**MONITORING YEAR 1
ANNUAL REPORT**
Final

CROSS CREEK RANCH SITE

Subject: Cross Creek Ranch Site – Monitoring Year 1 Draft Report
Montgomery County, NC
Yadkin River Basin – CU# 03040104
DMS Project ID No. 100138
Contract # 7879-01

Review Comments:

Figure 1. Current Condition Plan View
 Cross Creek Ranch Site
 DMS Project No. 100138
 Monitoring Year 1 - 2022

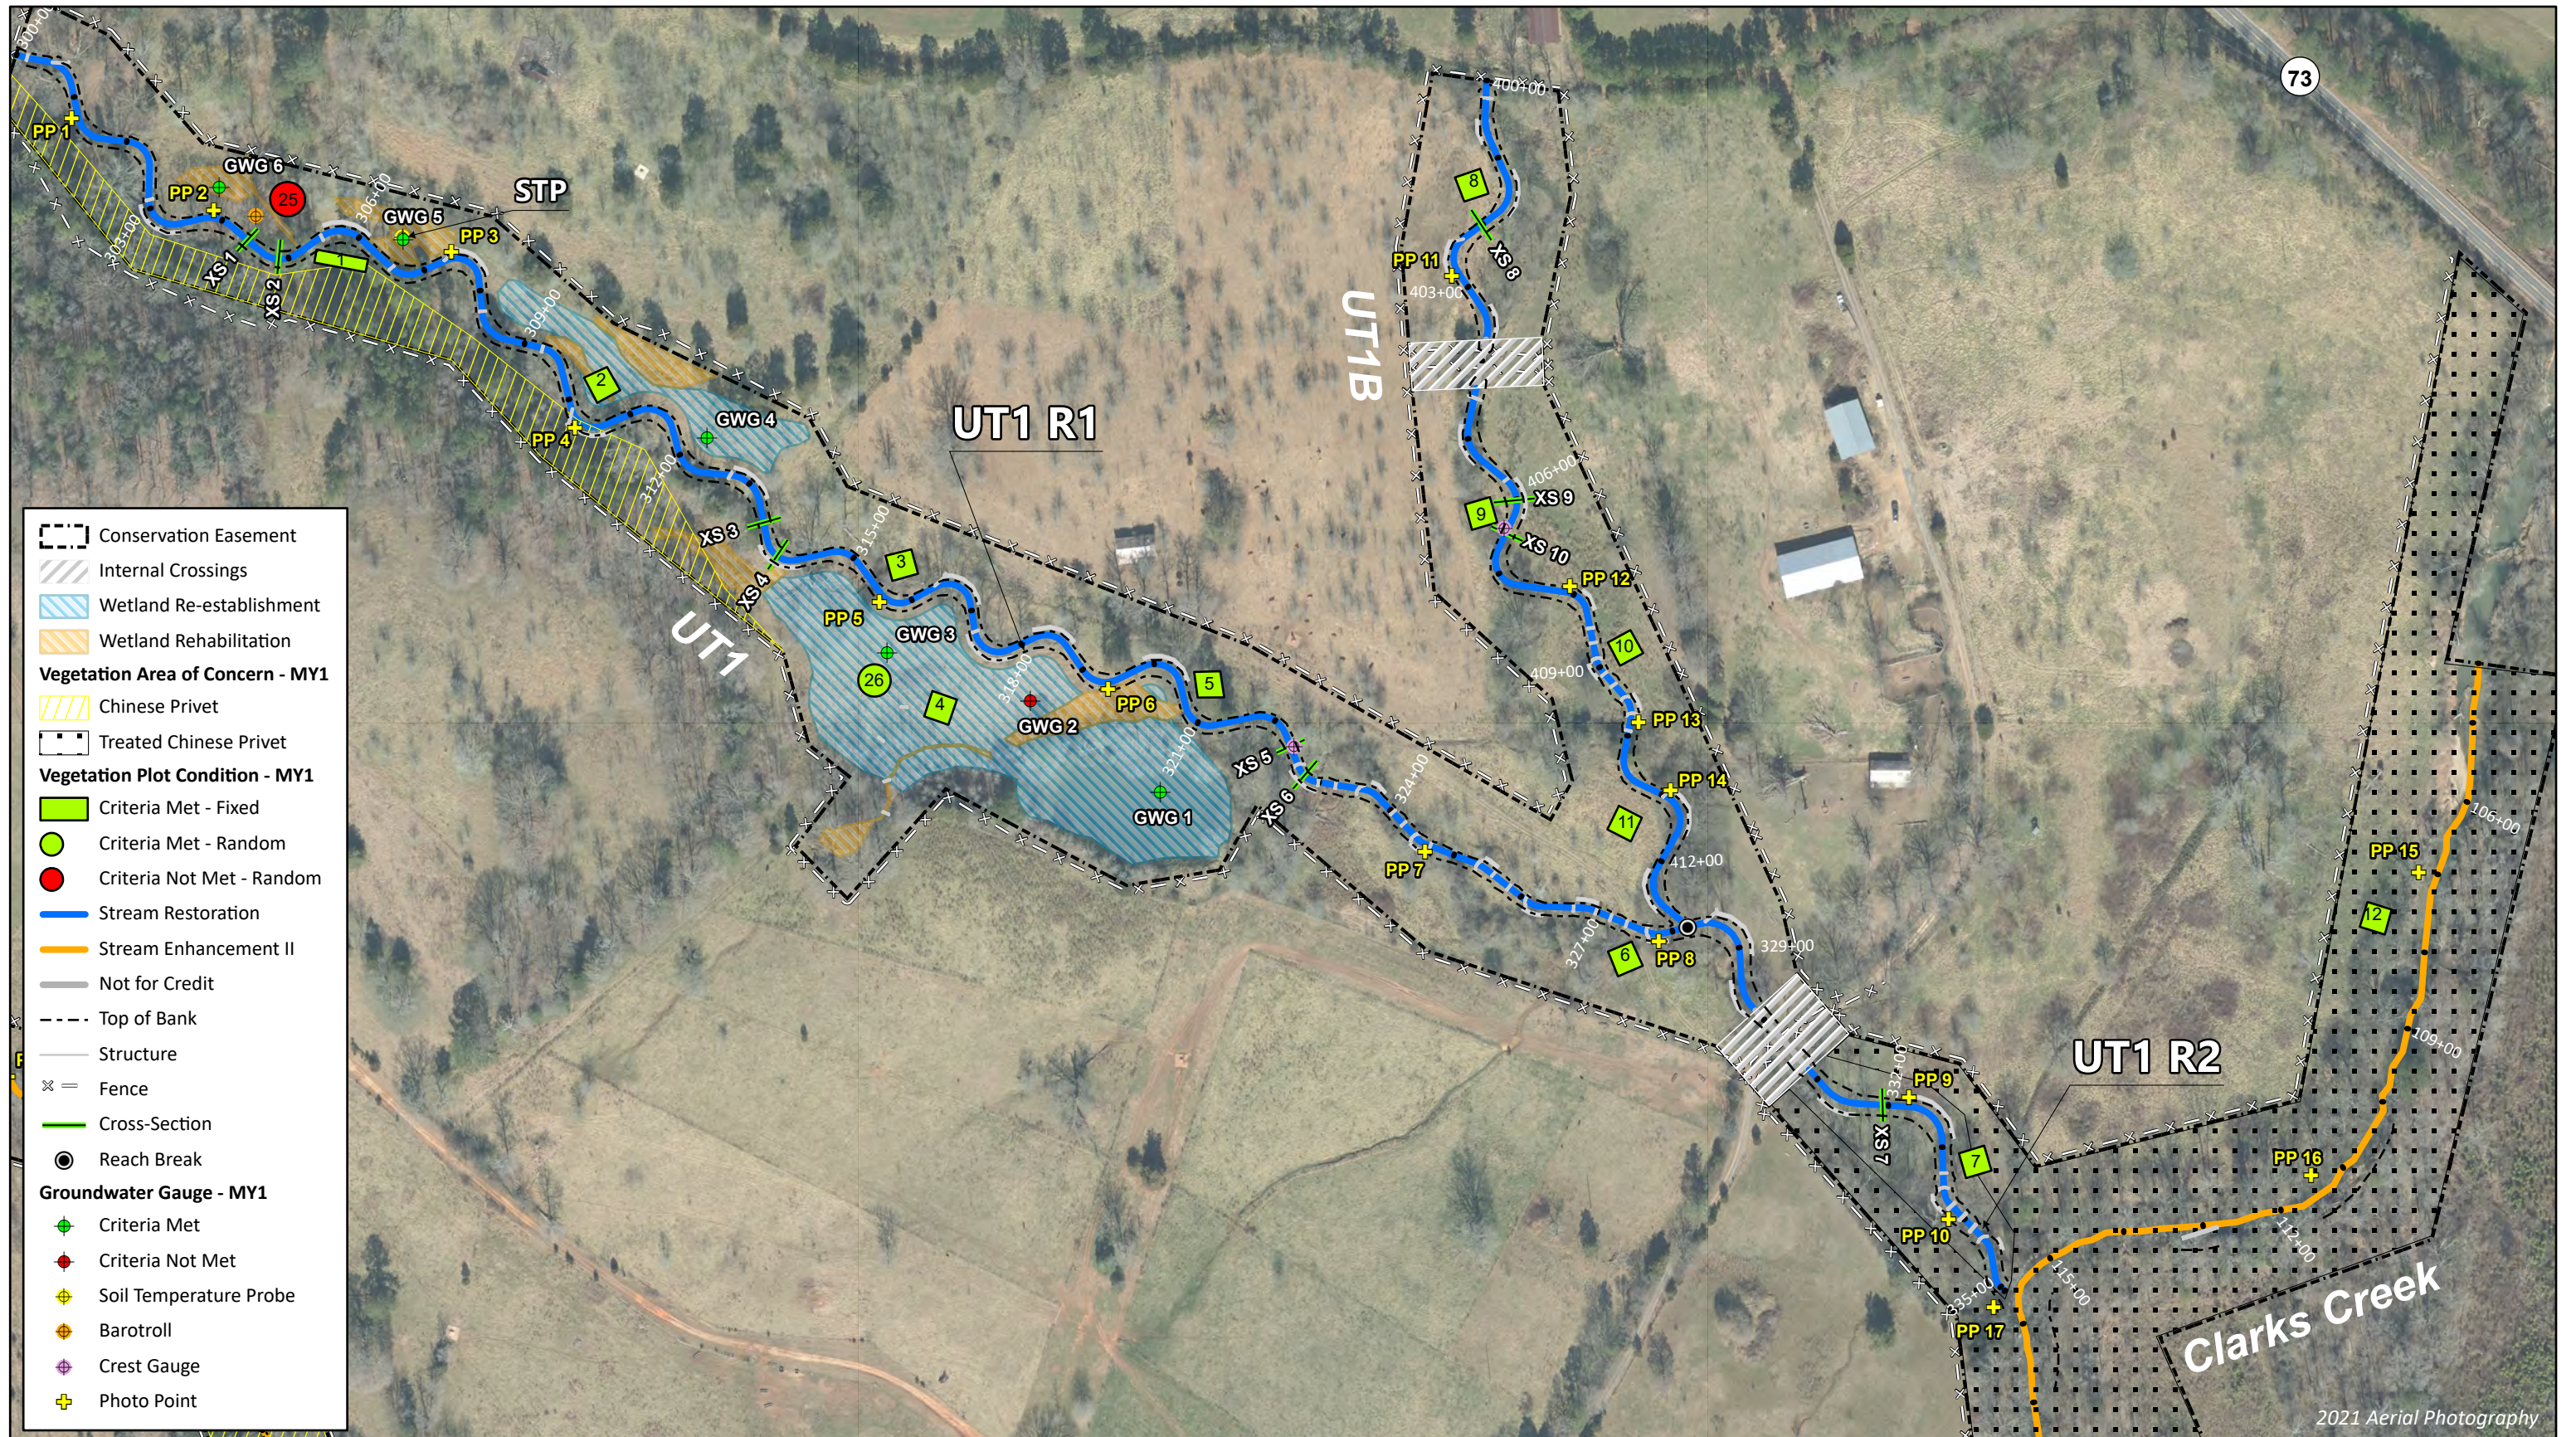
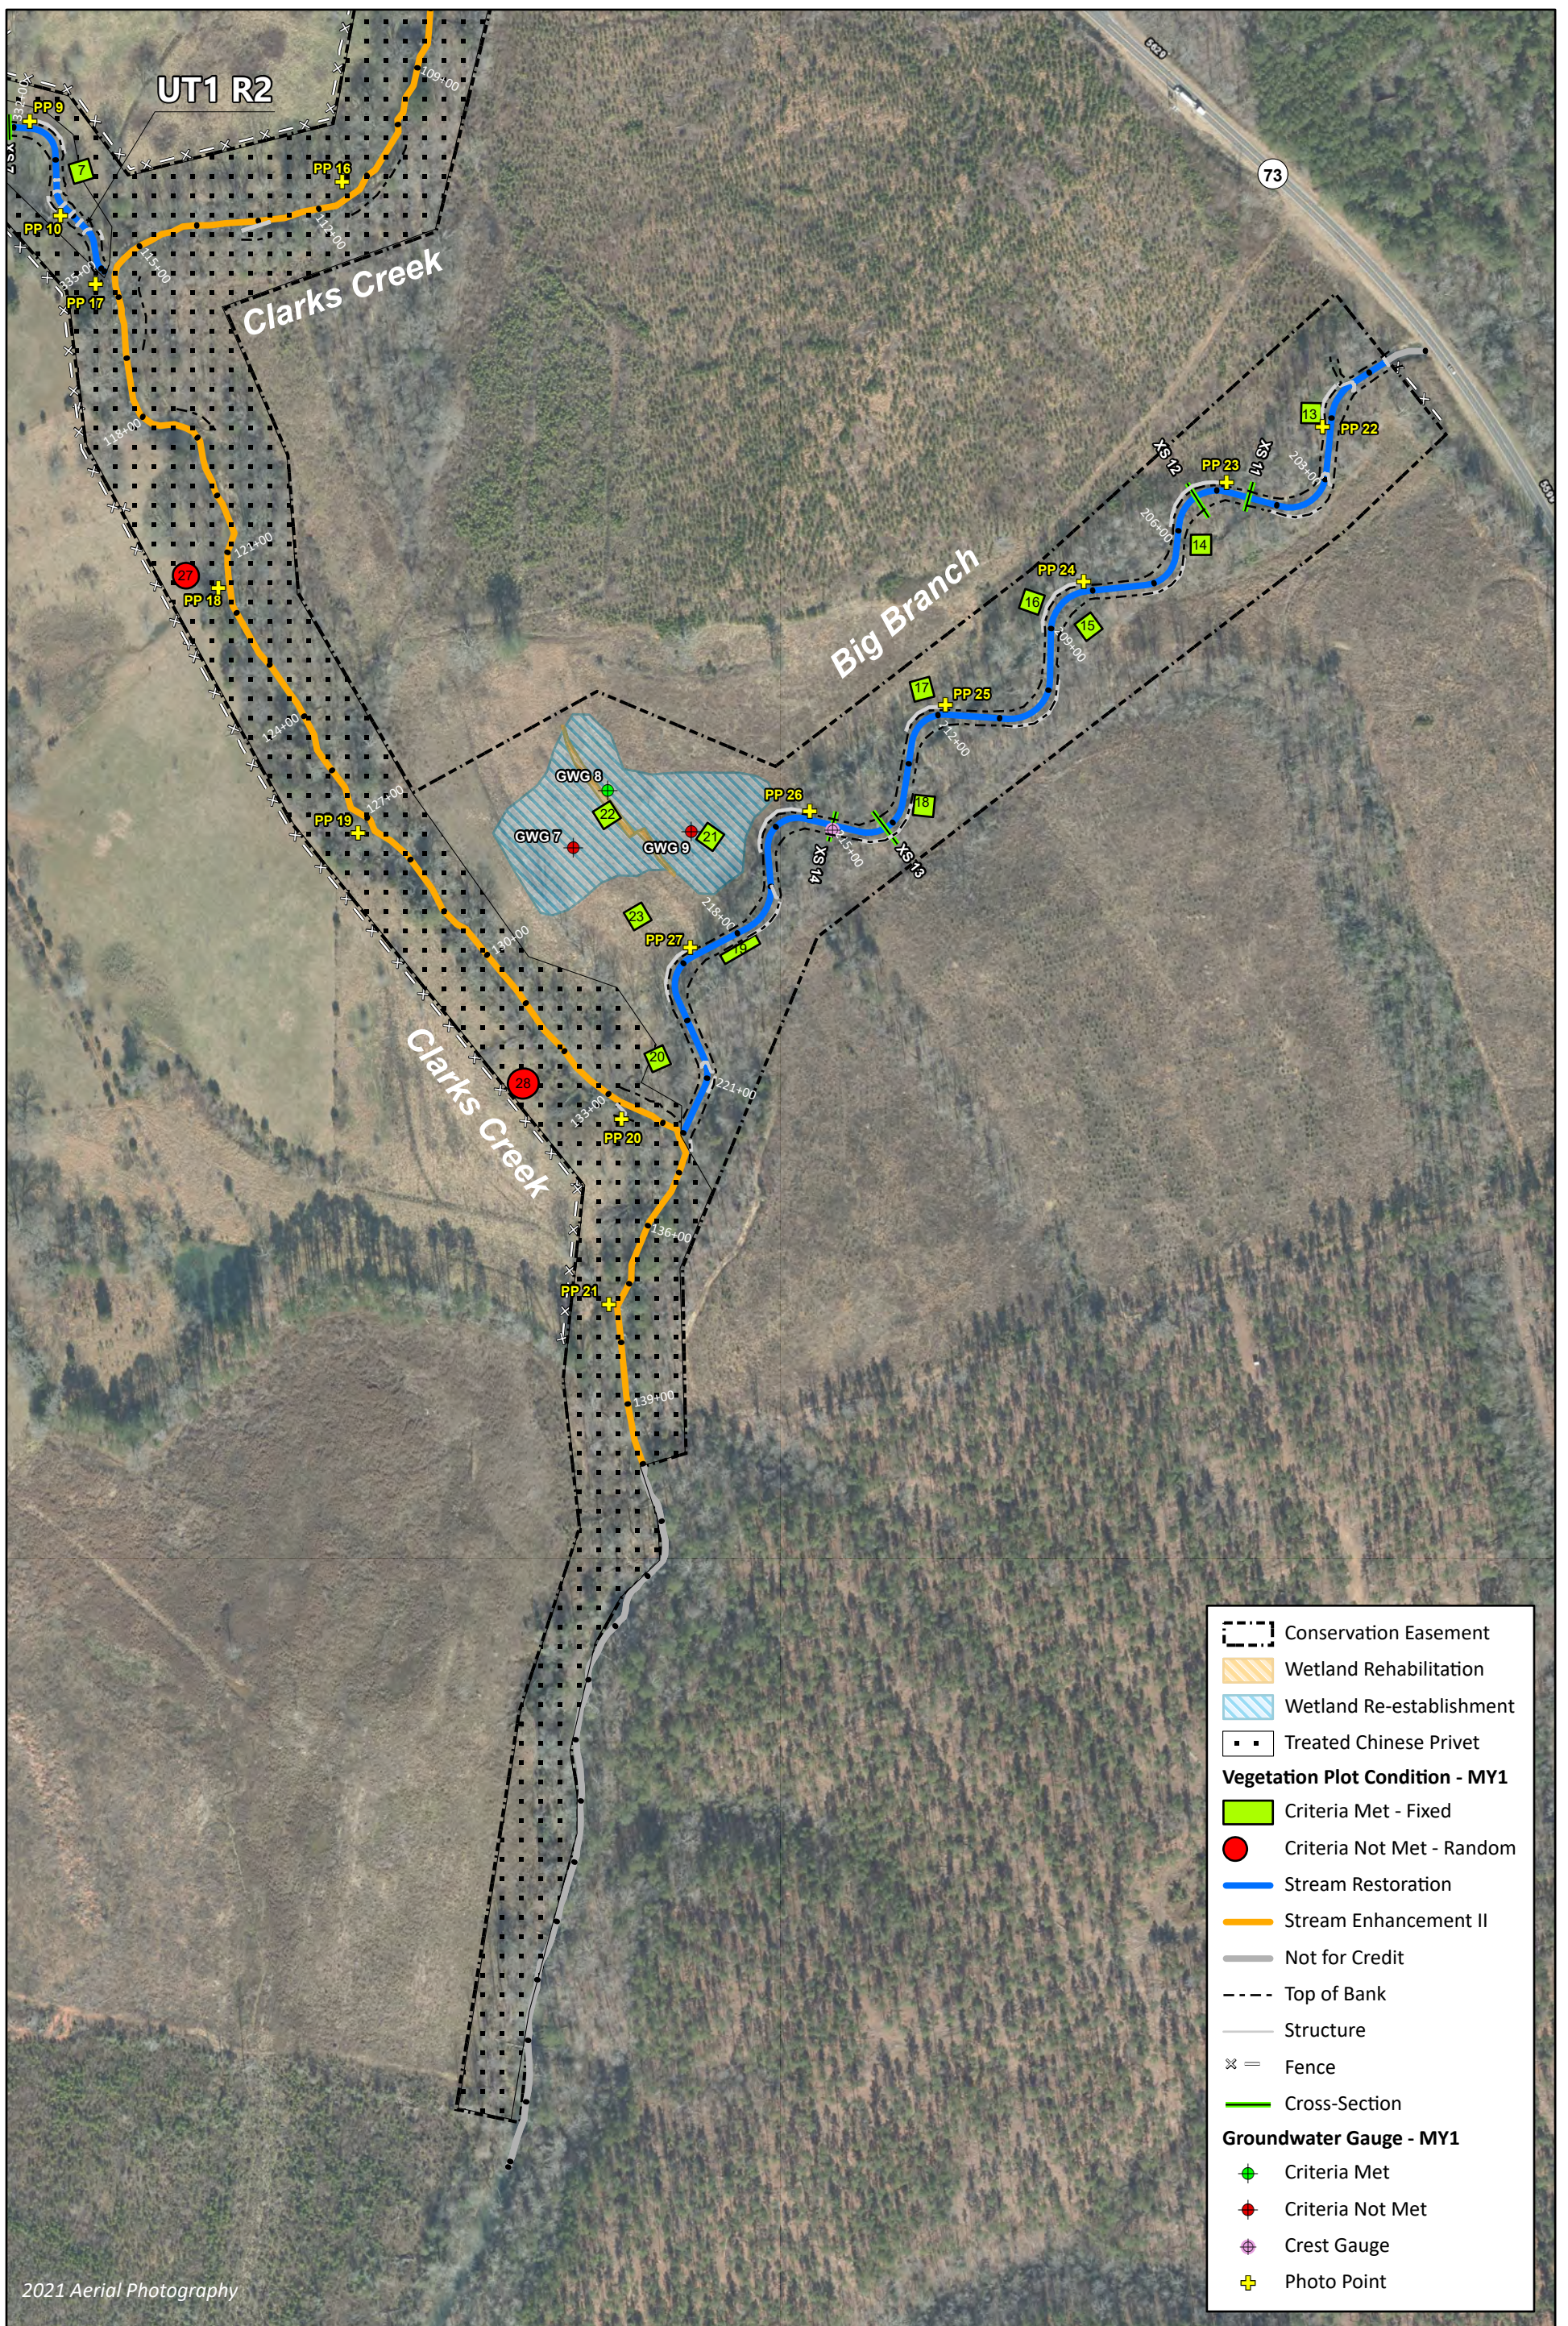
- [Section 1.2 – Monitoring Year 2 Data Assessment: The Table 2 goal of protecting the site from harmful uses includes visual inspection of the perimeter as the measurement criteria. Please summarize the monitoring activities and results associated with this goal and indicate if the entire easement boundary was observed during MY1 and marked in accordance with the marking specifications.](#)

Response: While the majority of the easement boundary was observed during MY1, it was not seen in its entirety. Easement marking specifications remain consistent with those portrayed in Figures 1a-c within boundaries observed during MY1. The boundary will be walked in its entirety during MY2, and the MY1 Monitoring Report has been updated to reflect this statement.
